**RE: Statement regarding D4D4 requirements for escalators at:  
28 Lockwood Ave, Belrose NSW 2085**

## **1. Summary**

Figure 1 – Extract of location of escalators at piazza (refer to annexed s4.55 plans)

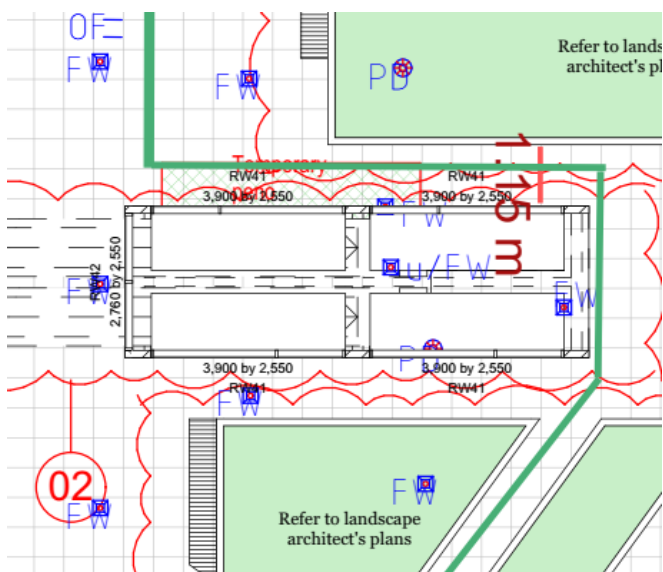
In relation to escalators, AS1428.1 specifically states at clause 6.1 that “a *continuous accessible path of travel shall not include a step, stairway, turnstile, revolving door, escalator, moving walk or other impediment*”.

BCA clause D4D4(f) further clarifies that access to each storey must be provided via a lift or ramp. Although stairs are also required to be AS1428.1 compliant where they are provided as a secondary means of reaching another storey, the AS1428.1 standard does not specify accessible features required for a escalators and refers to AS1735 for general escalator requirements. It is therefore recommended to consider that the building will meet the requirements of AS1428.1 providing the escalator is installed to the corresponding standard and also access is provided to those same parts of the building.

The s4.55 plans for this development show that accessways are provided to parts of the building independently of the escalator addition. Accordingly it is recommended to consider that the modified areas of the building where the escalators are provided with access consistent with the CC plans and the recommendations of the original Access Report dated 30 October 2024 remain unchanged.
